110 FIRST AVE WEST

SDCI LAND USE REVIEW
CORRECTION NOTICE #1
(Issued 01/03/19)

Perspective at the corner of Western Ave W & 1st Ave W

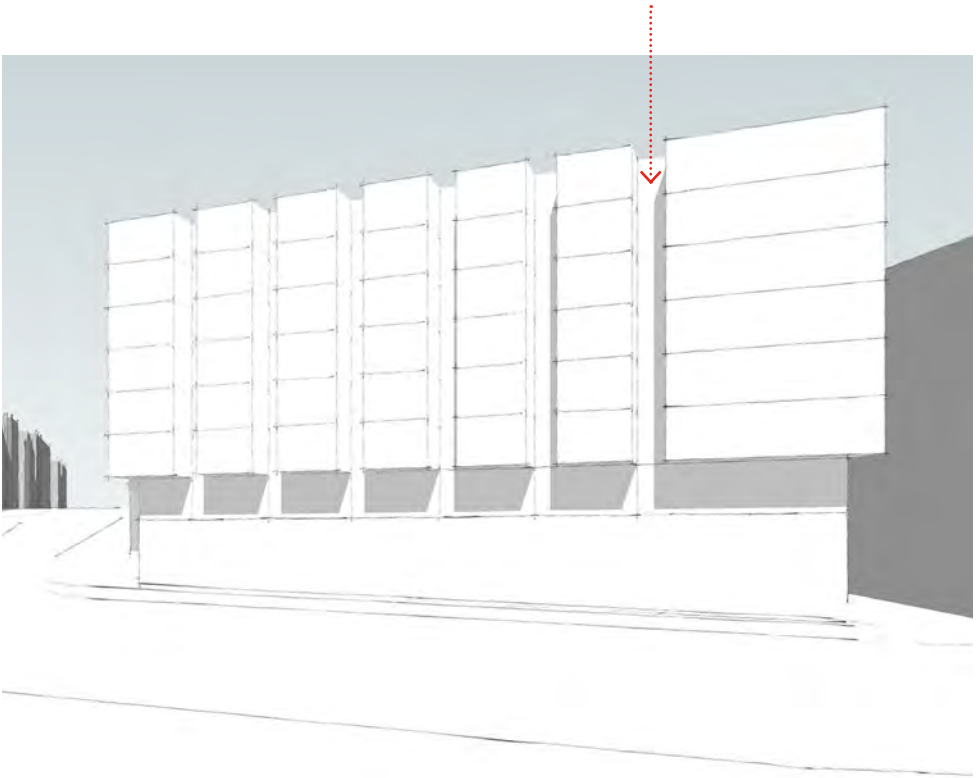
b. Board members spent a considerable amount of time discussing the possibility of balconies in the interstitial “hinge” at the project’s northwestern façade. They felt that balconies in this area could add an extra layer of details and visual interest to the building. They reserved judgment for balconies in other locations. They requested a study of balcony options and an explanation of the pros and cons of the design options. (DC 1, DC 2, & DC 3)

Response: Each street-facing residential unit in the building has a private balcony. Metal / glass balconies are proposed along the building’s primary (Western Ave W) façade at the upper levels while balconies on Level 3 are integrated within the building’s mass. These integrated balconies provide both protection and privacy to its occupants given their proximity to Western Ave W. These balconies are further screened by street trees that pick up the rhythm of the building’s articulated bays and niches. At the rear of the building, Juliette balconies occur at each upper unit, while the four units on Level 3 have private decks with direct access to a shared courtyard / dog run.

The balconies add depth and relief to the building’s mass in an effort to distinguish it from its commercial neighbors, which lack architectural detail and articulation (Salvation Army Building, Northwest Work Lofts). The balconies provide outdoor amenity space for each of the west-facing units. Their generous size will encourage use and animation of the façade.
